**ADDENDUM NO. 1
TO CONTRACT DOCUMENTS
FOR
LYNDON DRIVE STORMWATER REPAIRS
FOR
CITY OF LANCASTER, SOUTH CAROLINA**

BIDS DUE: January 10, 2023

Addendum Prepared By
KECK & WOOD, INC.
January 4, 2023

EXHIBIT NO.

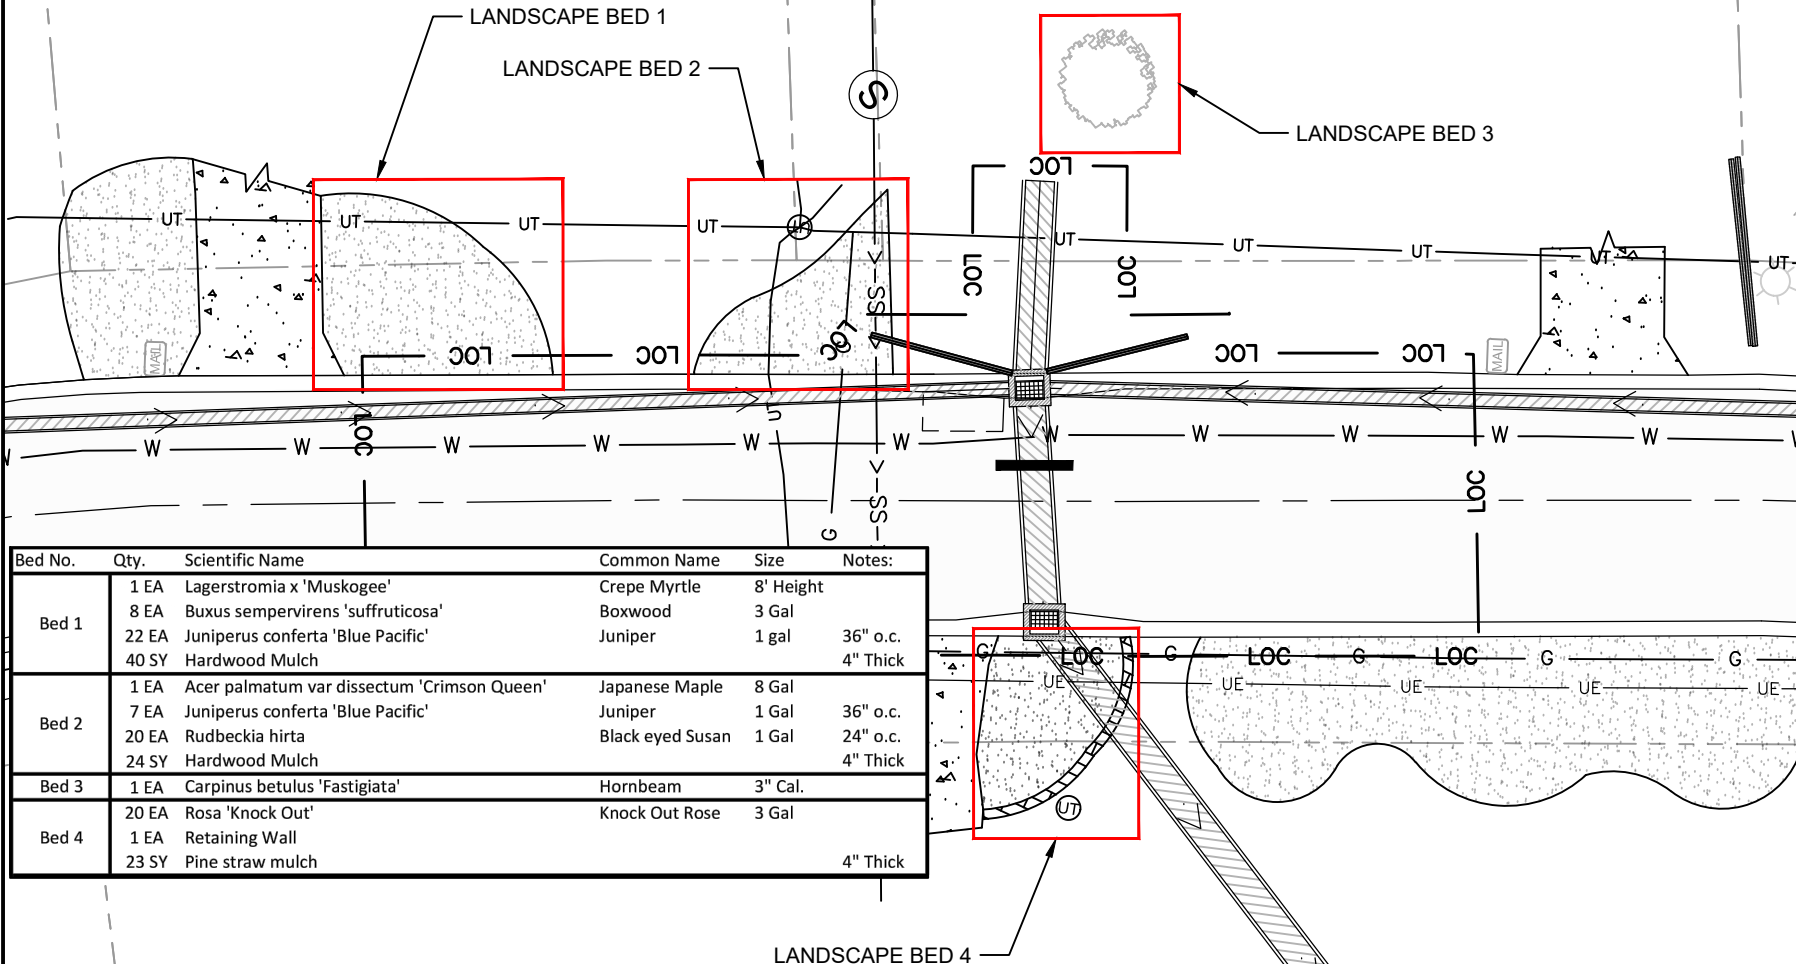
2. Unit of Measurement: Square Yard (SY)
3. In Section 004100, Bid Form, line items 15-18 shall reference Unit Price No. 14: Landscaping Repair and Replace. These line items shall be priced per Exhibit No. 1 attached to this addendum. The successful contractor shall submit a schedule of values for each landscaping bed after the contract is awarded.

Bed No.	Qty.	Scientific Name	Common Name	Size	Notes:
Bed 1	1 EA	Lagerstromia x 'Muskogee'	Crepe Myrtle	8' Height	
	8 EA	Buxus sempervirens 'suffruticosa'	Boxwood	3 Gal	
	22 EA	Juniperus conferta 'Blue Pacific'	Juniper	1 gal	36" o.c.
	40 SY	Hardwood Mulch			4" Thick
Bed 2	1 EA	Acer palmatum var dissectum 'Crimson Queen'	Japanese Maple	8 Gal	
	7 EA	Juniperus conferta 'Blue Pacific'	Juniper	1 Gal	36" o.c.
	20 EA	Rudbeckia hirta	Black eyed Susan	1 Gal	24" o.c.
	24 SY	Hardwood Mulch			4" Thick
Bed 3	1 EA	Carpinus betulus 'Fastigiata'	Hornbeam	3" Cal.	
Bed 4	20 EA	Rosa 'Knock Out'	Knock Out Rose	3 Gal	
	23 SY	Pine straw mulch			4" Thick
